Final Environmental Impact Statement

Great Plains Gasification Project

**Mercer County
North Dakota**

August 1980

REVISED FIGURE 3-27

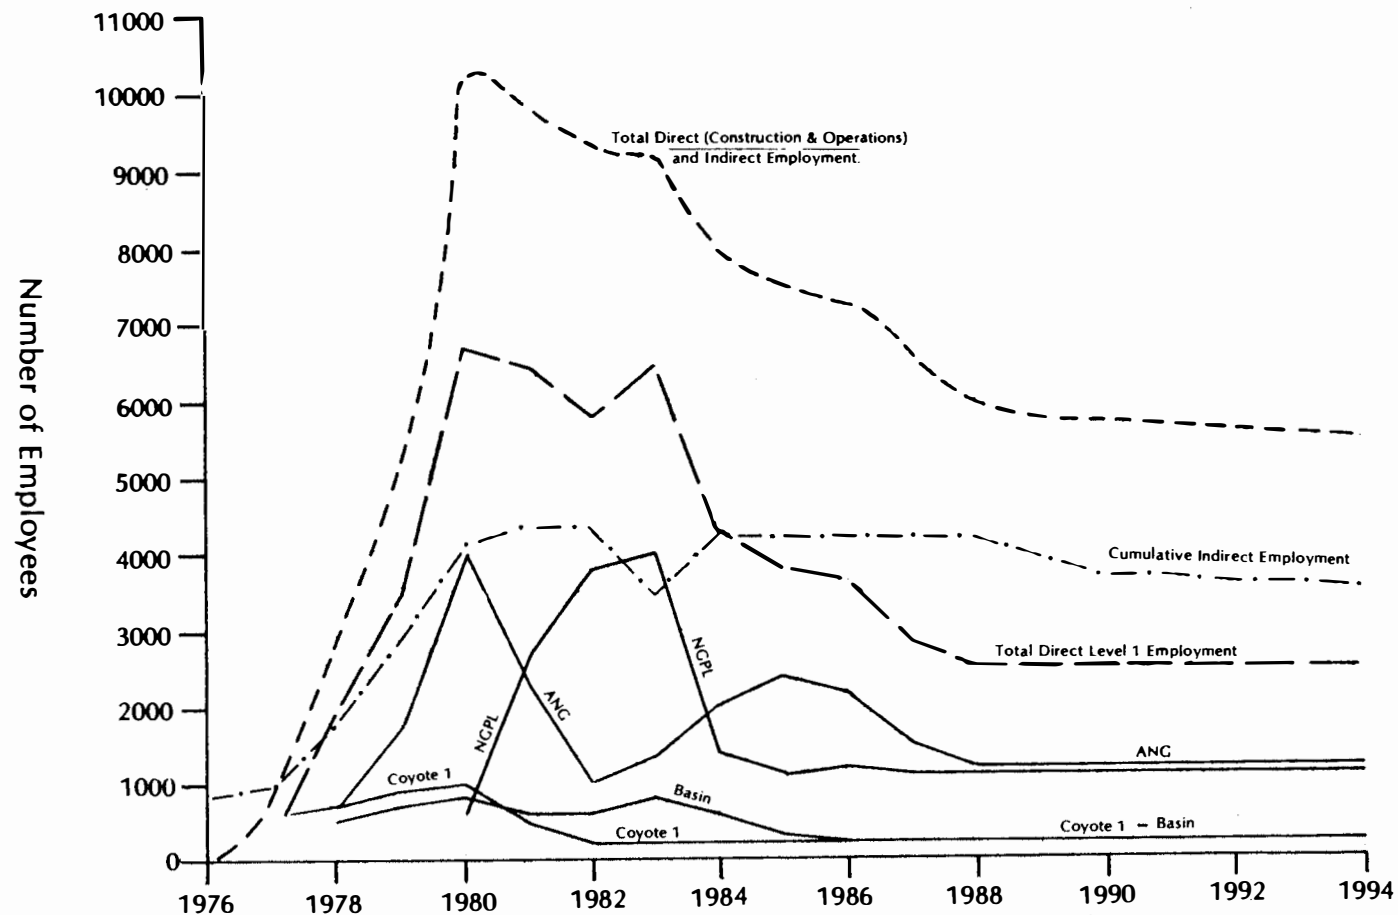
Figure 3-27. This figure indicates that cumulative indirect employment estimates for 1981 are approximately 3500 employees. However, the E-D output lists the peak indirect employment in 1981 at 4543. It is important that the illustrations approximate the estimates as closely as possible.

Figure 3-27 is revised as shown:
